UNITED STATES OF AMERICA  
NUCLEAR REGULATORY COMMISSION

In the Matter of	)	
	)	
CONSUMERS POWER COMPANY	)	Docket Nos. 50-329 OM & OL
	)	50-330 OM & OL
(Midland Plant, Units 1 and 2	)

NRC STAFF TESTIMONY OF DARL S. HOOD, JEFFREY K. KIMBALL AND EUGENE GALLAGHER

ON STAMIRIS CONTENTION 1

FSAR Figure 2.5-48A

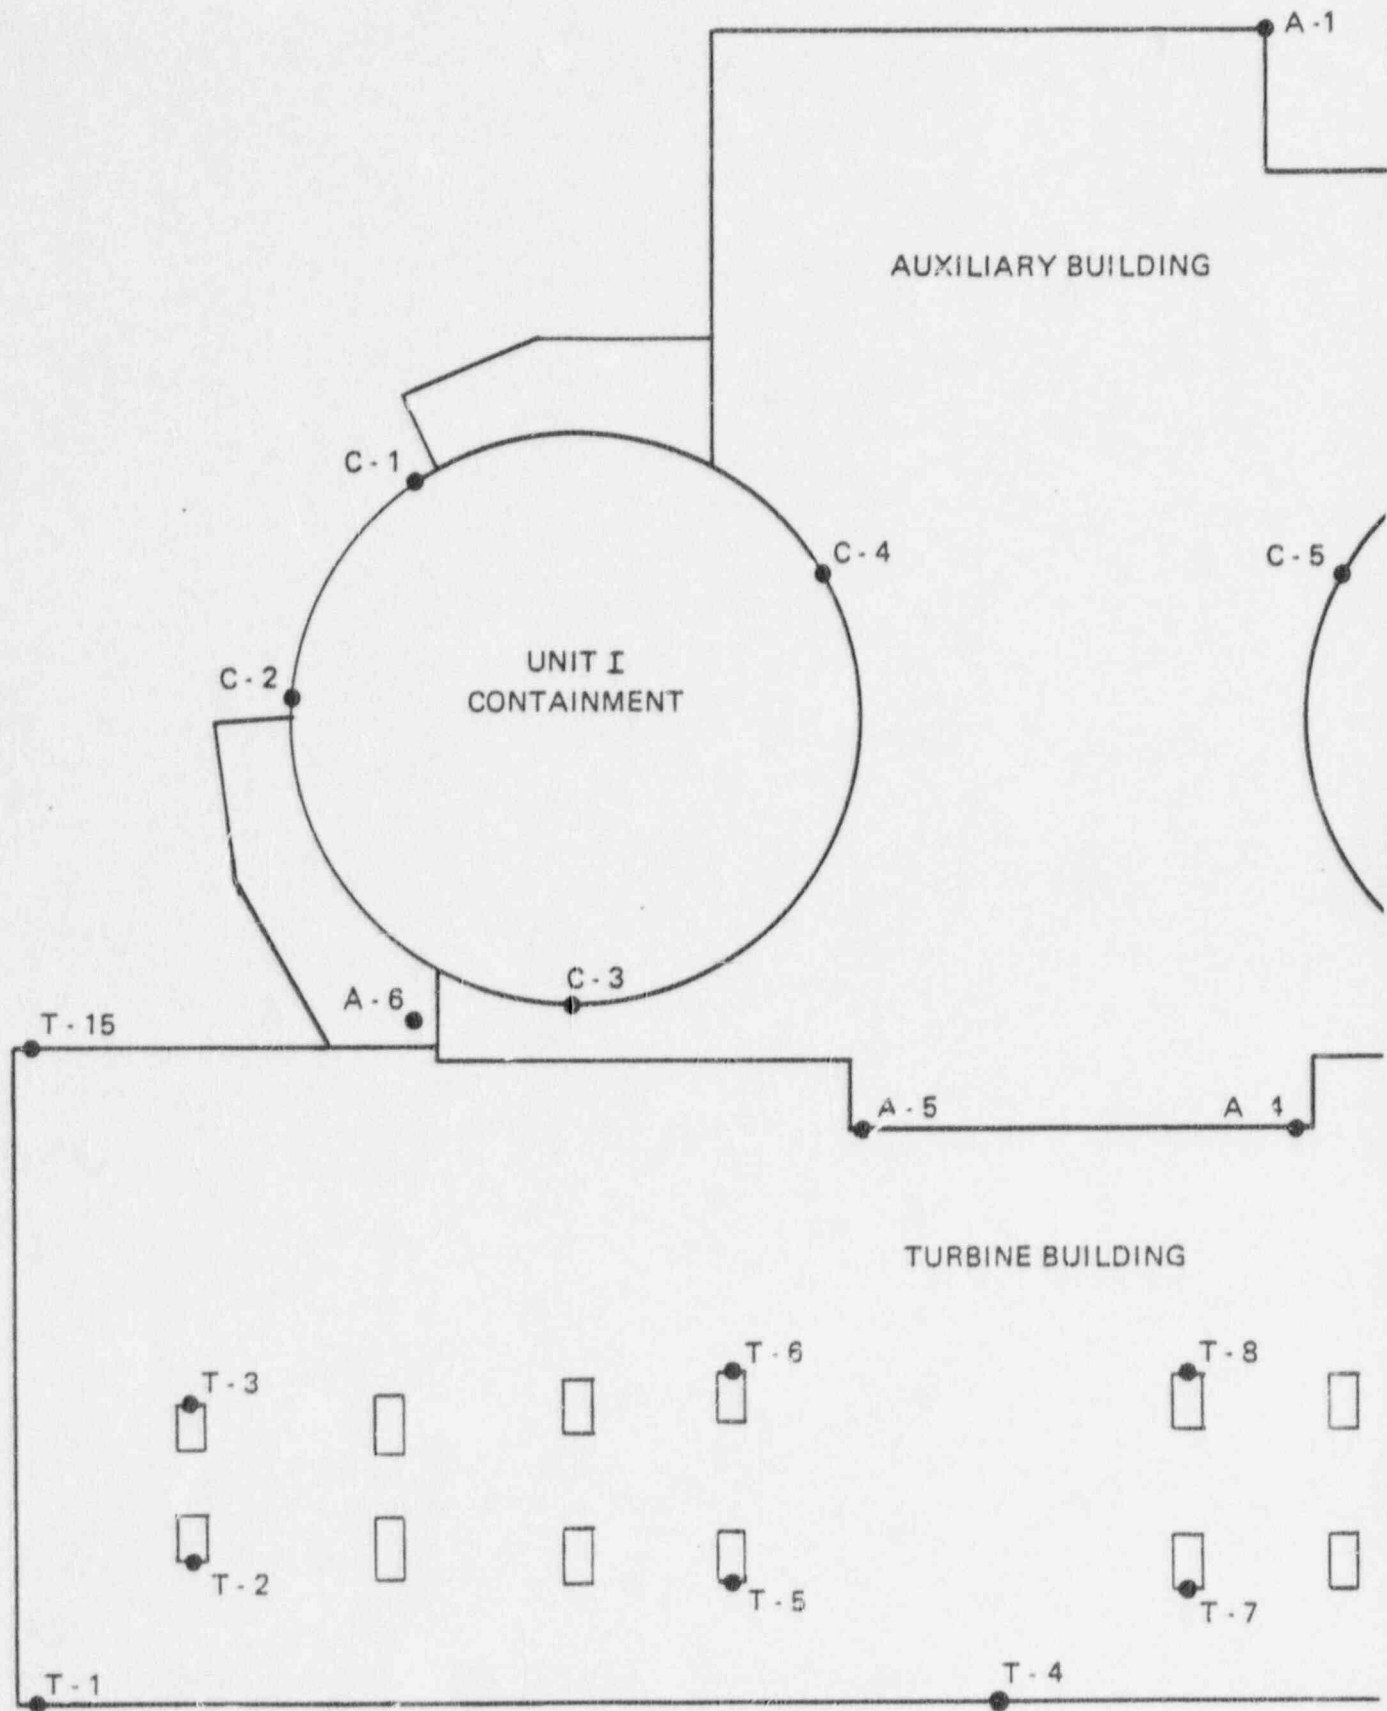
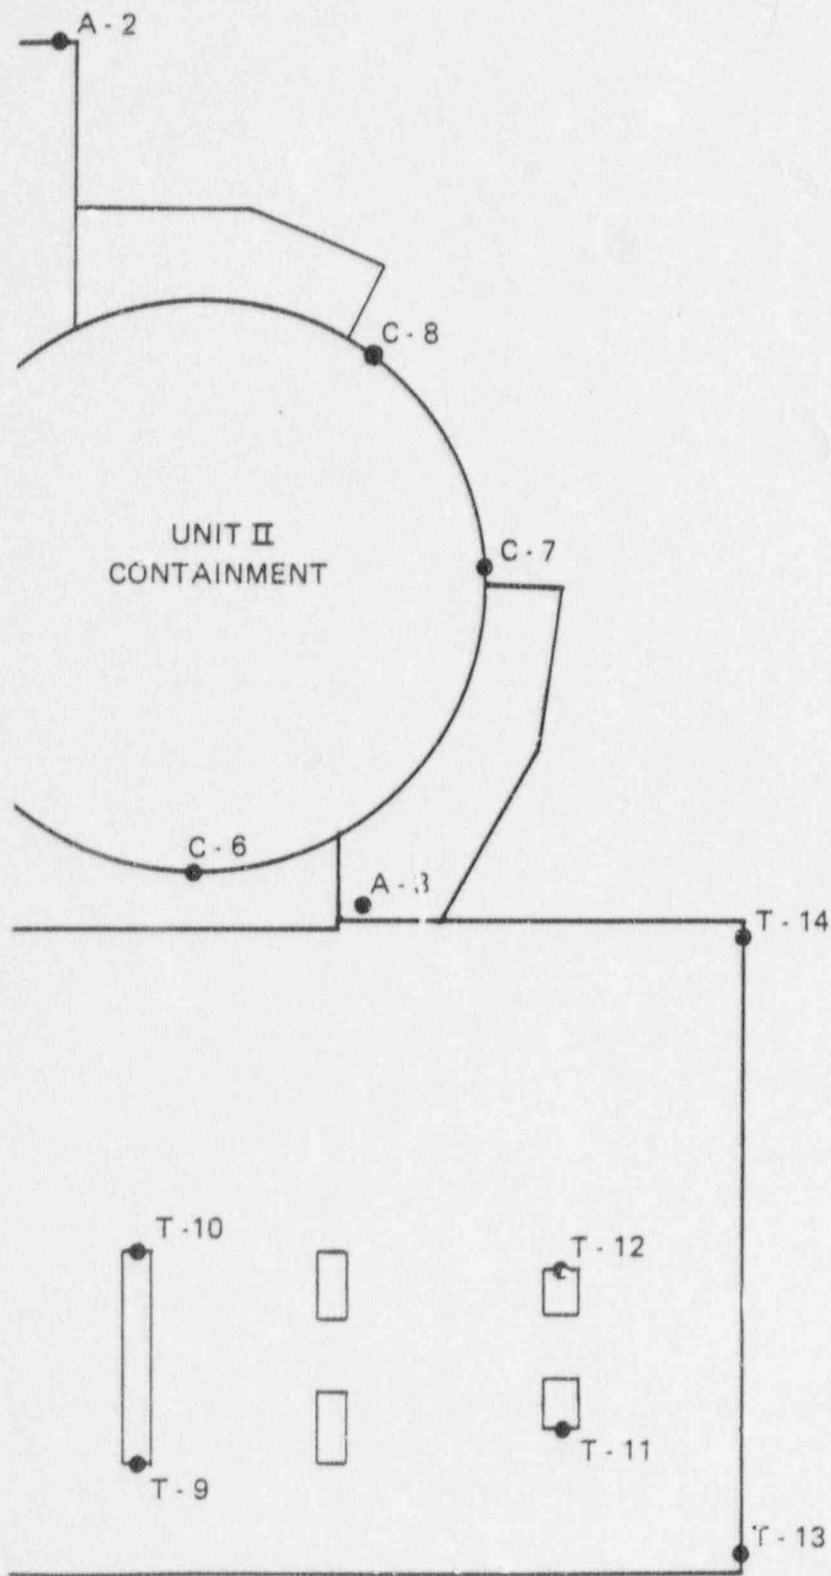
The response to Request 362.4 is insufficient. Table 2.5-14A shows the structural settlement measurements available to date. Provide the reasons for the lack of survey data at Benchmark Numbers A-3 and 4; C-2, 3, 4, 5, 6, and 7; and T-2, 5, 6, 7, 8, 9, 10, 11, 12, 13, 14, and 15. In Subsection 2.5.4.13.1 of the FSAR, reference is made to Figure 2.5-78. The figure number is in error and should be corrected.

Table 2.5-14A has been revised to include the settlement measurements for the subject benchmark numbers.

Subsection 2.5.4.13.1 has been revised to reference the correct figure.

Settlement benchmarks have been installed and monitored at selected locations on the major plant structures. Benchmark locations are shown in Figure 2.5-48A. Benchmark elevation measurements are presented in Table 2.5-14A.

Measured settlements were not measured from the start of construction. Available settlement measurements are presented graphically in Figures 2.5-89 through 2.5-91 for the reactor, auxiliary, and turbine buildings. Building load intensities estimated from actual material quantities used in construction are also shown in Figures 2.5-89 through 2.5-91.
